Subject: ABNORMAL NOISE WHEN OPERATING ELECTRIC STEERING TILT/TELESCOPIC FUNCTION	Bulletin No.: 06-003/23
	Last Issued : 07/11/2023

2024 CX-90 (with electric tilt/telescopic steering) with VINS lower than JM3KK*****107178 (produced before March 24, 2023)

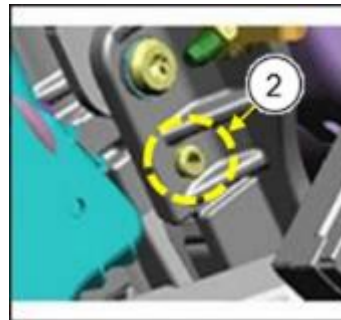
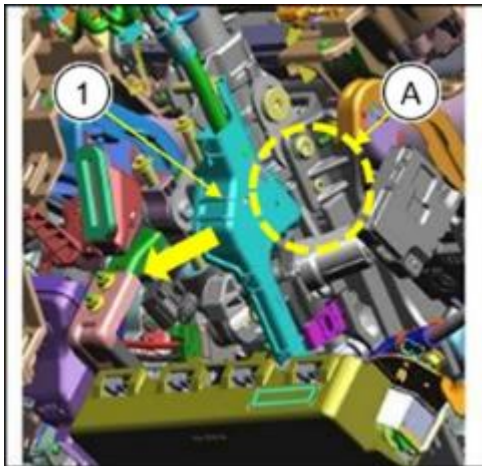
1. Verify the customer concern.
2. Loosen the set screw at the right side of the steering column tilt according to the following procedure.

b. Remove the bolt (1) (2pcs.).

c. Move the wire harness cover (1) toward the yellow arrow, then loosen the set screw (2) 90 (+/- 10) degrees using a hexagonal wrench.
